## **BID ADDENDUM NO. 2**

February 20, 2026  
Elmira City School District  
EHS 2025 Capital Improvements  
2012-242

SED #07-06-00-01-0-016-027 – High School

**AD2-E1**

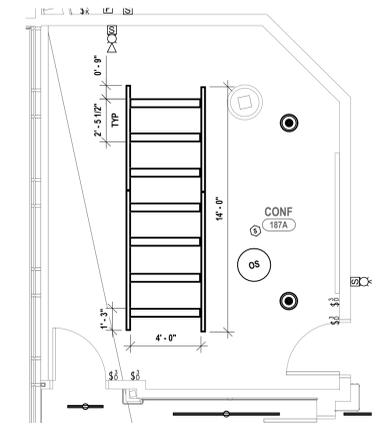
**ADD** Note to drawing as shown on AD2-E1 - NEW TRANSFORMER as issued in this  
addendum.

**HS-E2.1**  
 PROJECT NO: 2012-242

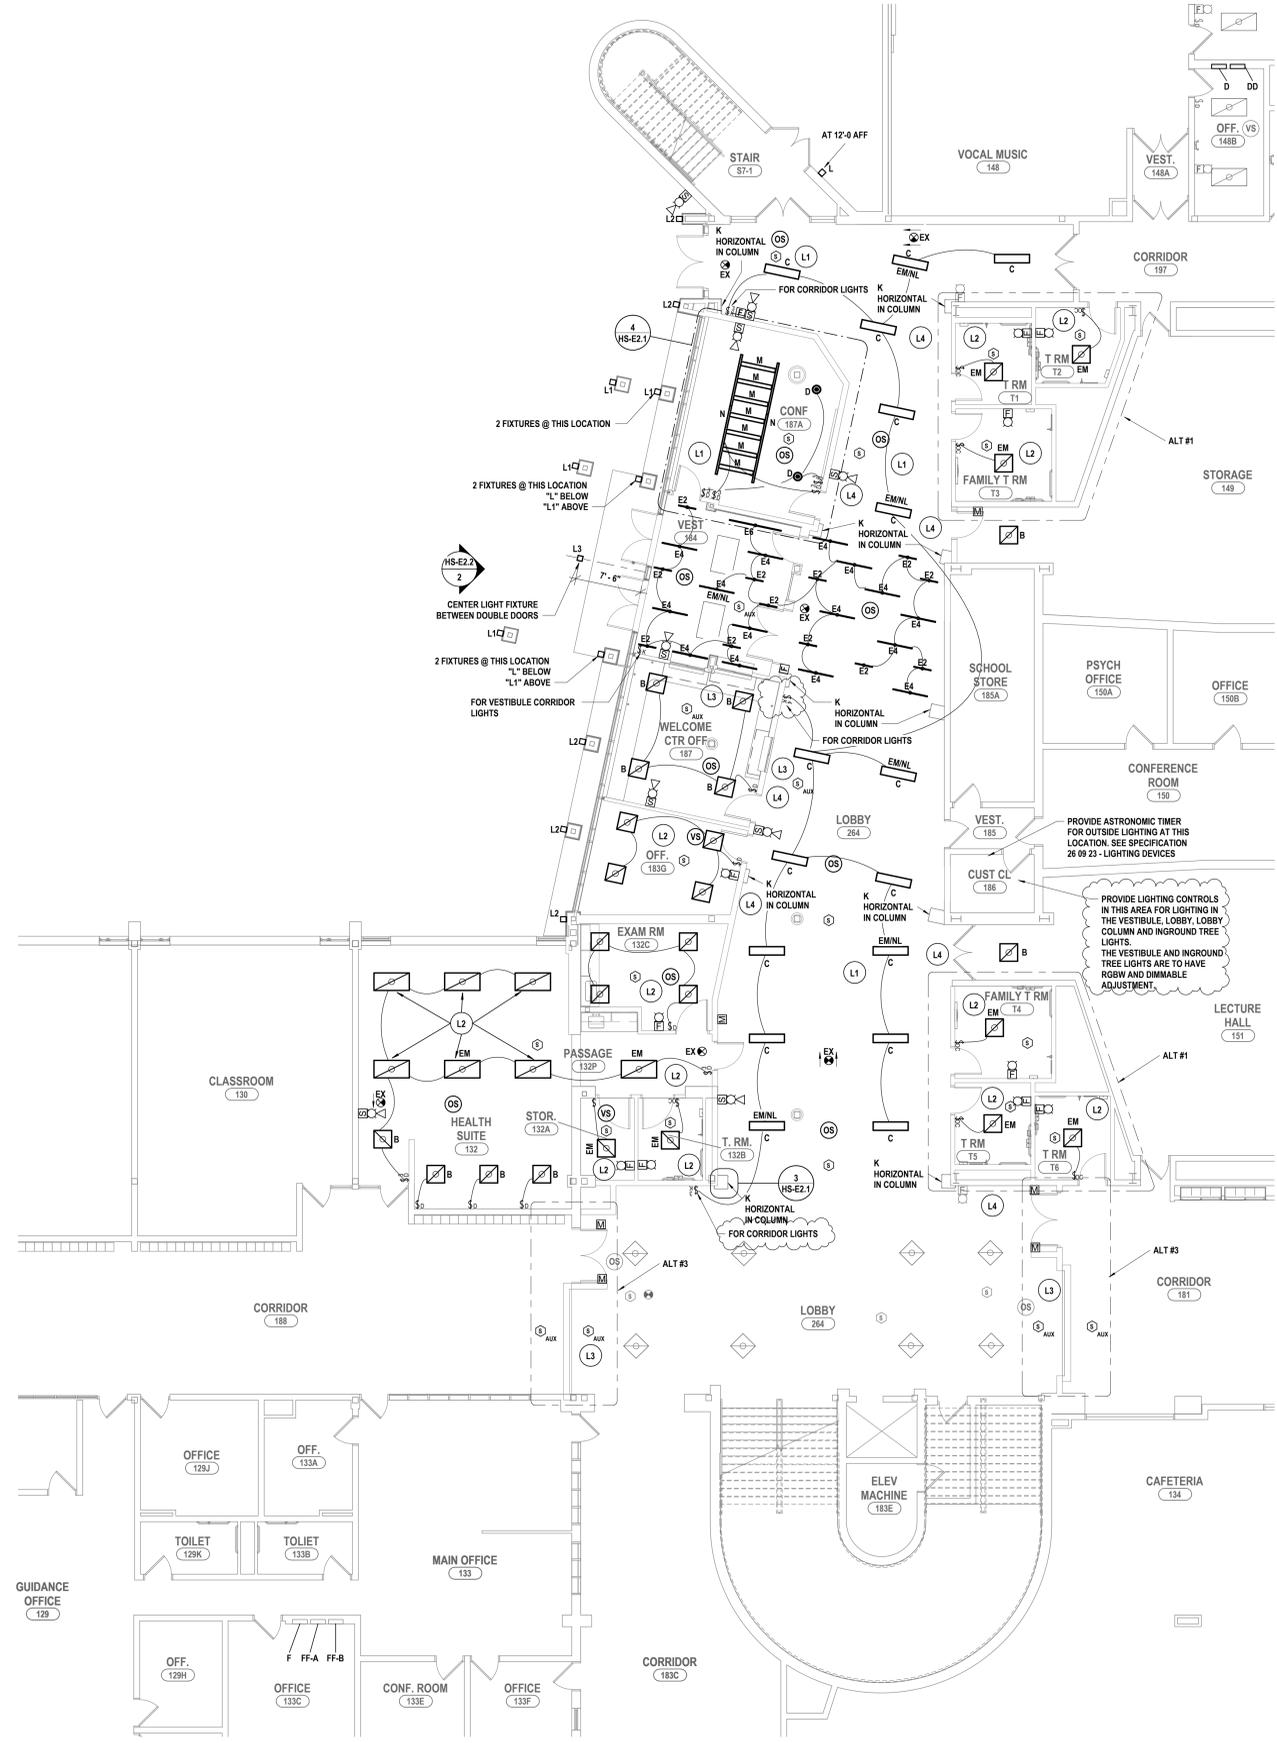
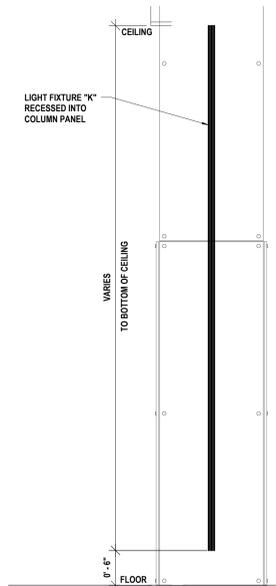
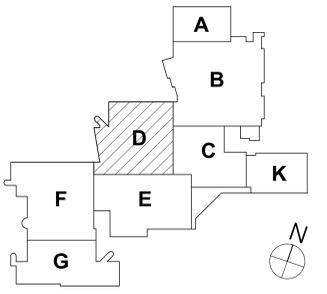
**DELETE** Drawing HS-E2.1 - FIRST FLOOR LIGHTING AND FA PLAN in its entirety and

**ADD** Drawing HS-E2.1 - FIRST FLOOR LIGHTING AND FA PLAN as issued by this  
addendum.

**FIRST FLOOR TECHNOLOGY PLAN**  
**EHS 2025 CAPITAL IMPROVEMENTS**  
**ELMIRA CITY SCHOOL DISTRICT**  
 777 SOUTH MAIN STREET ELMIRA, NY 14904  
**HS-T1.2**  
 PROJECT NO: 2012-242

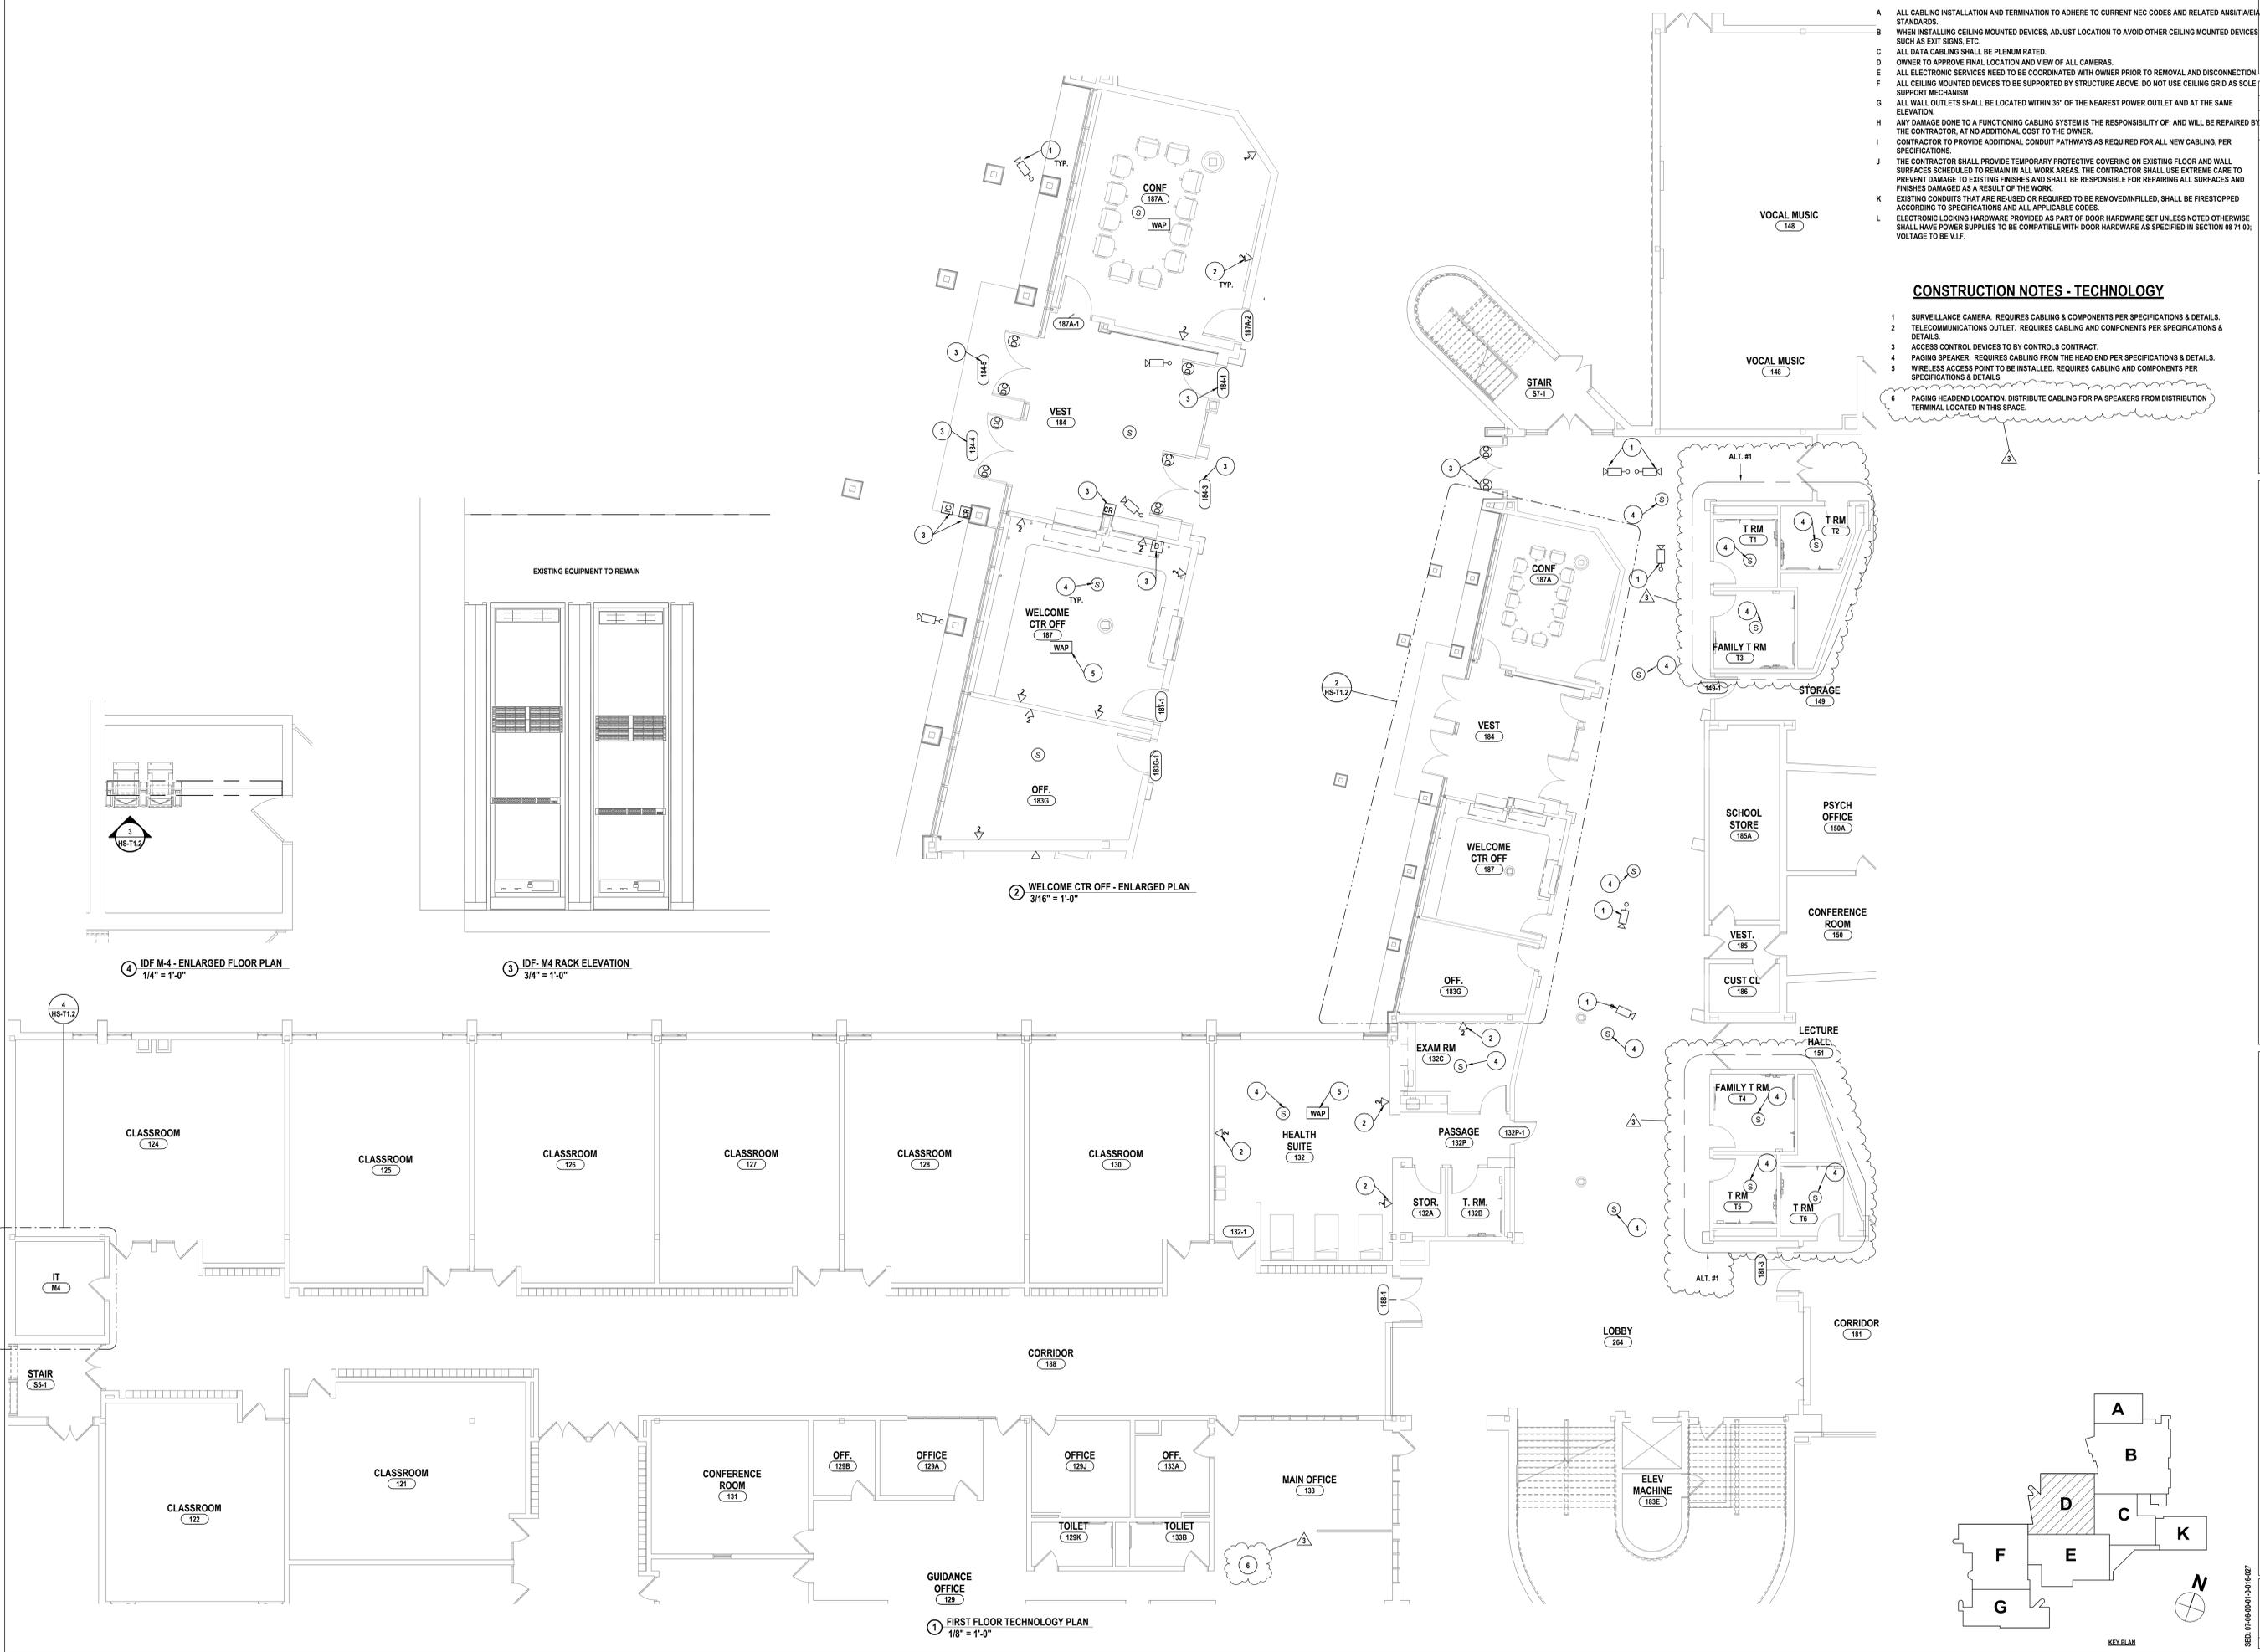
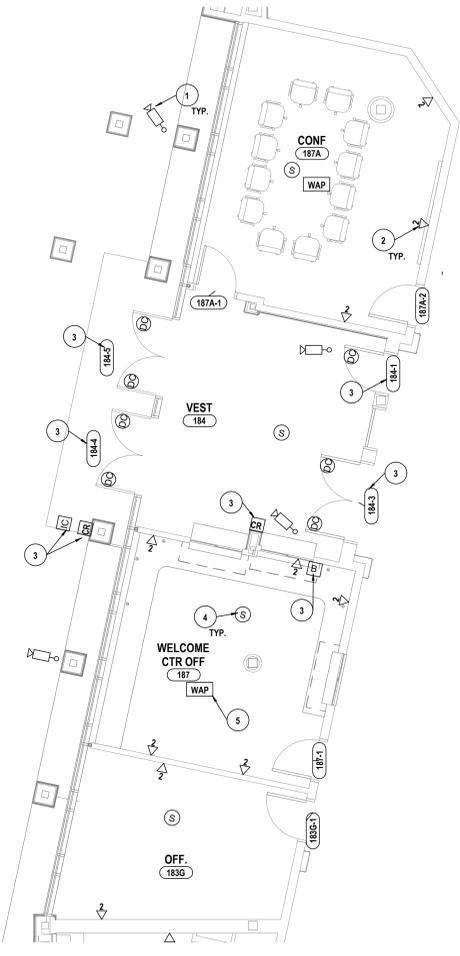
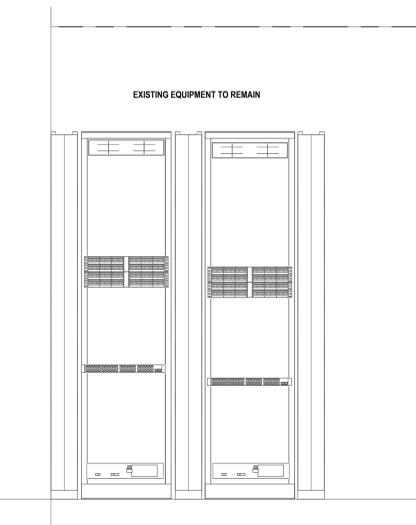
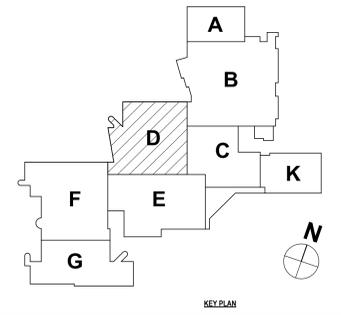
**DELETE** Drawing HS-T1.2 - FIRST FLOOR TECHNOLOGY PLAN in its entirety and

**ADD** Drawing HS-T1.2 - FIRST FLOOR TECHNOLOGY PLAN as issued by this addendum.
